ATTACHMENT I

PROPOSED TECHNICAL SPECIFICATION CHANGES

SINGLE RECIRCULATION LOOP OPERATION

POWER AUTHORITY OF THE STATE OF NEW YORK  
JAMES A. FITZPATRICK NUCLEAR POWER PLANT  
DOCKET NO. 50-333

Fig 3.5-4

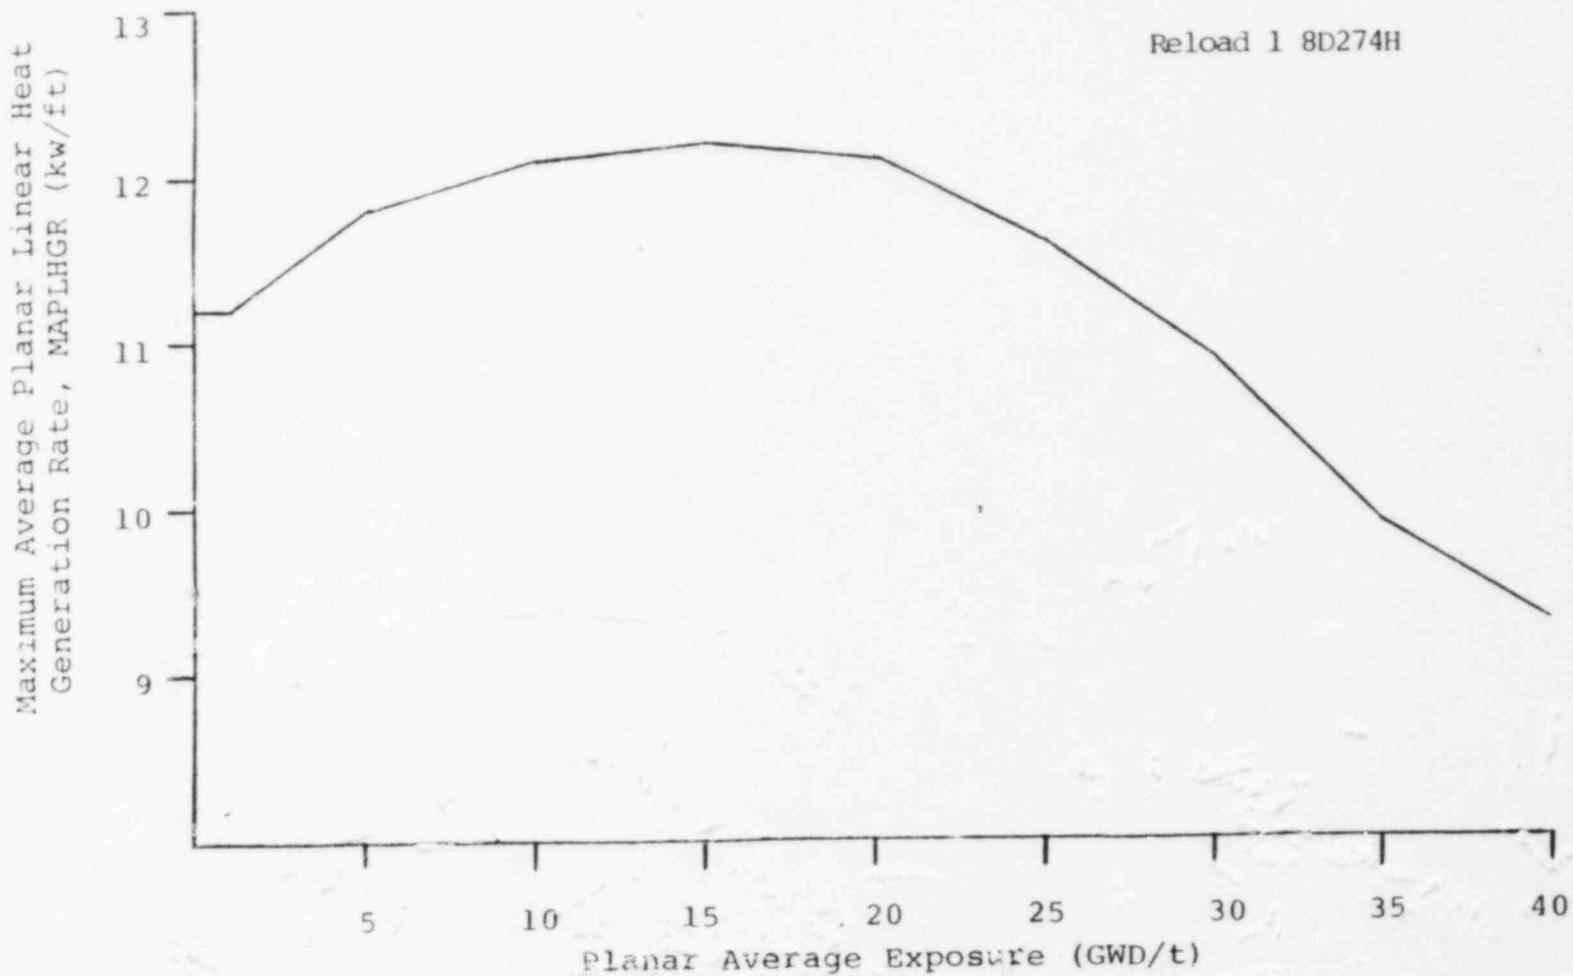
For single recirculation loop operation, these MAPLHGR values should be multiplied 0.84.

Fig 3.5-5

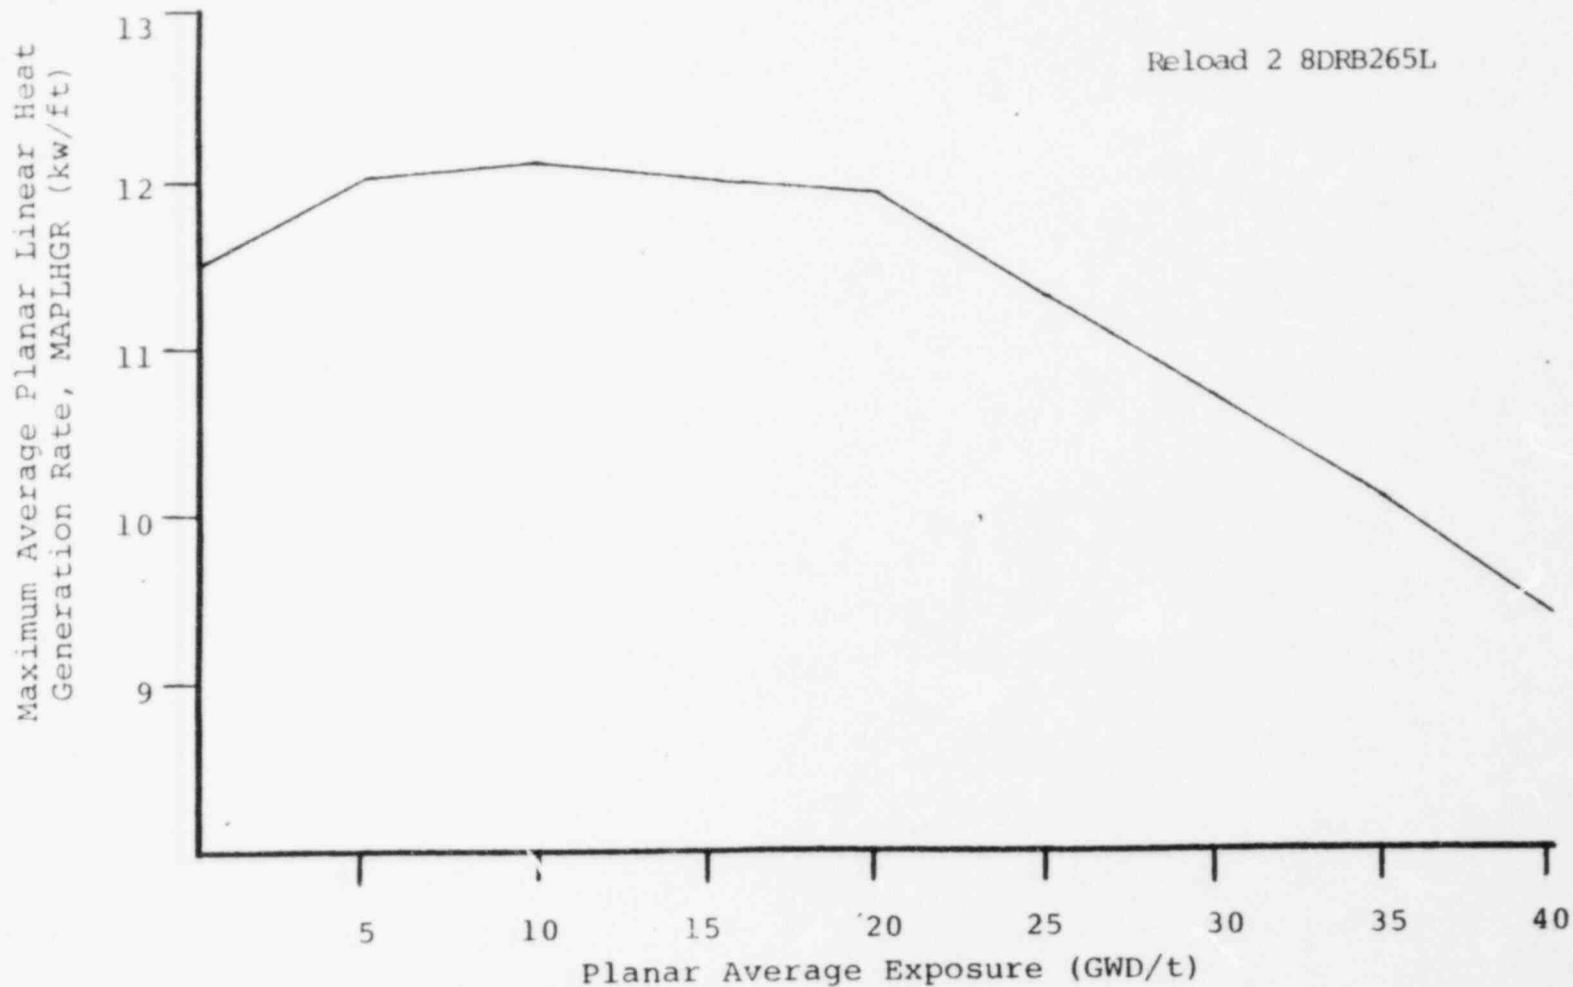
For single recirculation loop operation, these MAPLHGR values should be multiplied 0.84.

Fig 3.5-6

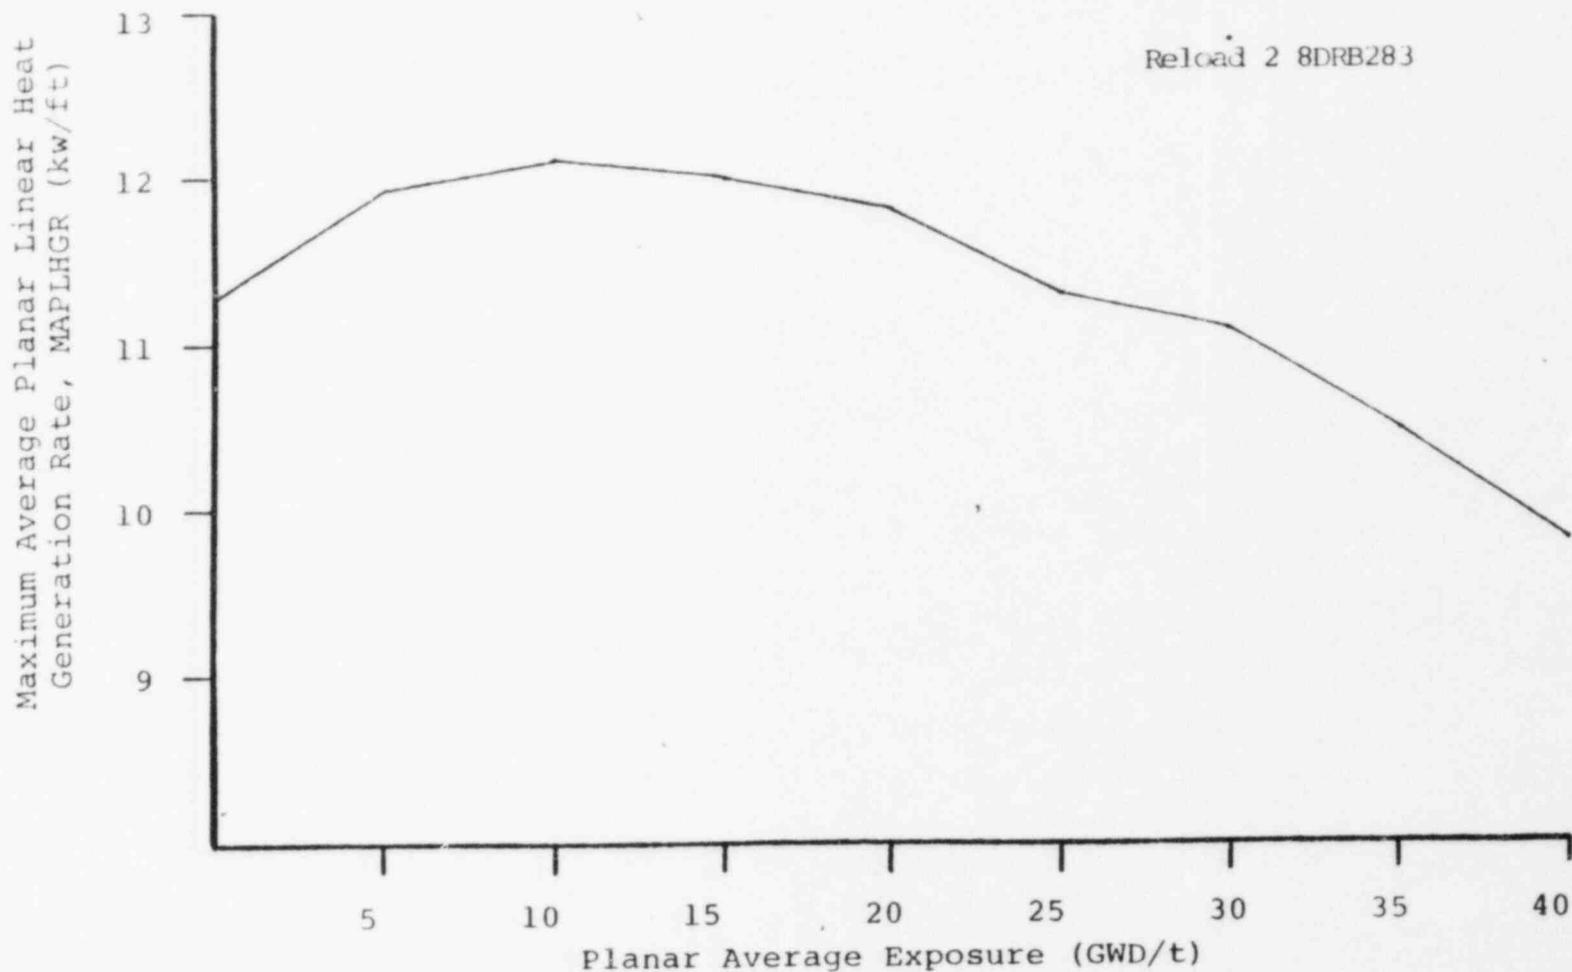
For single recirculation loop operation, these MAPLHGR values should be multiplied 0.84.

Fig 3.5-7

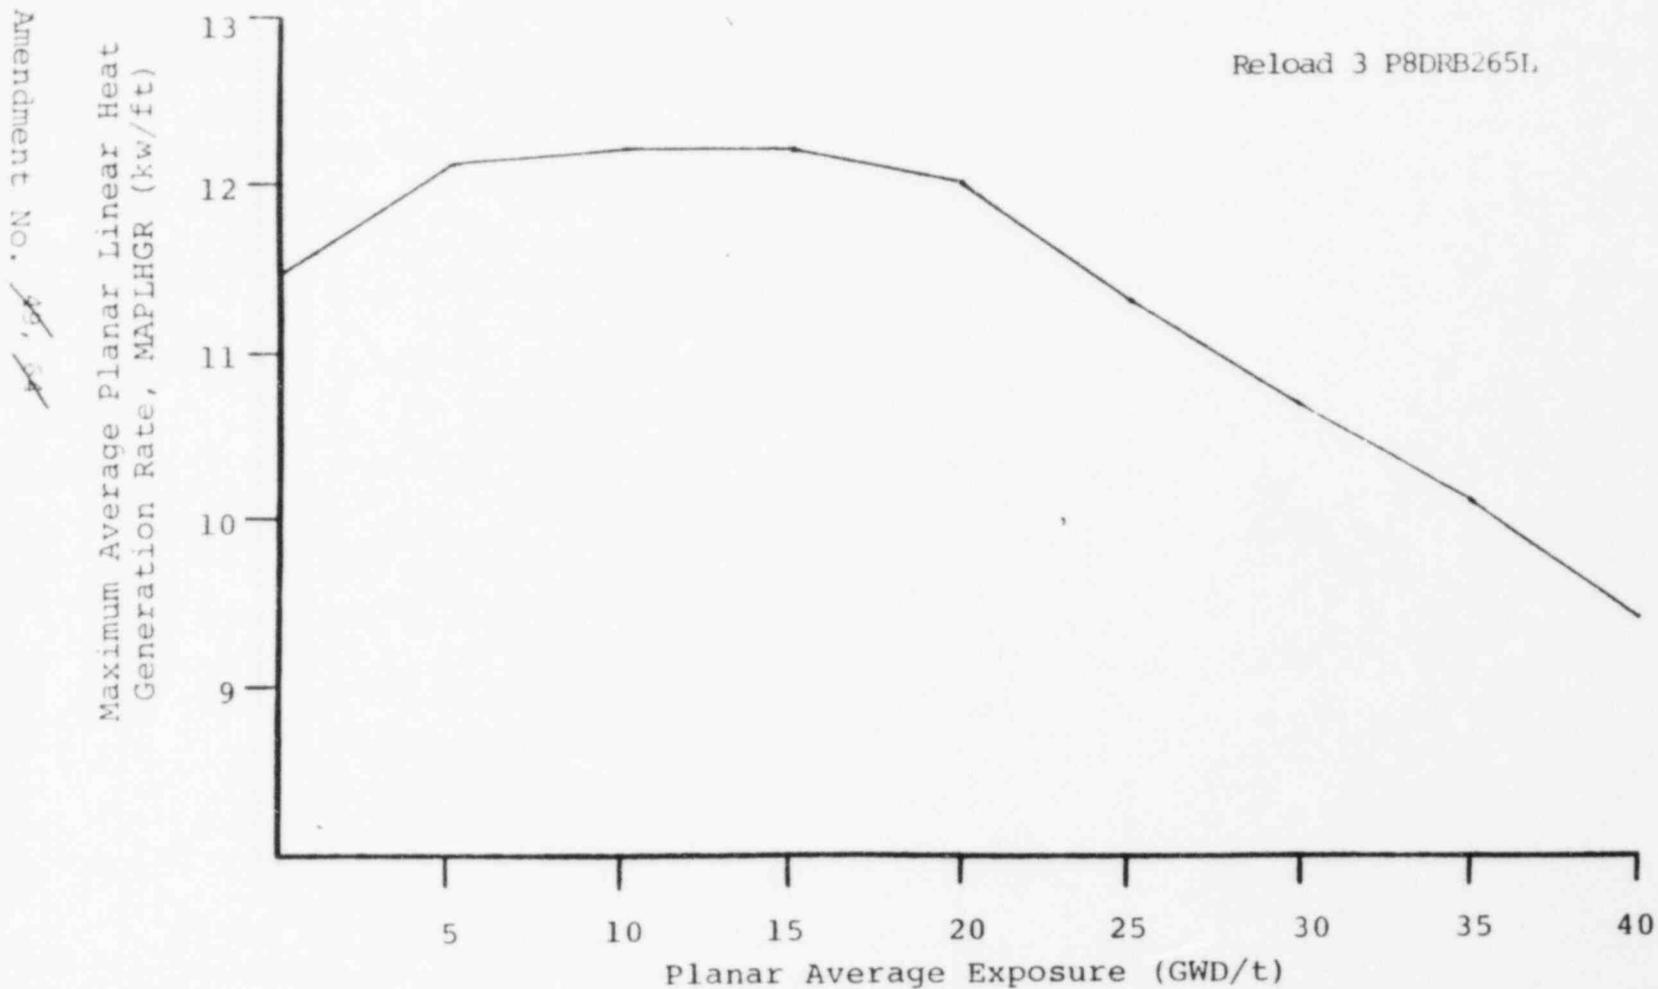
For single recirculation loop operation, these MAPLHGR values should be multiplied 0.84.
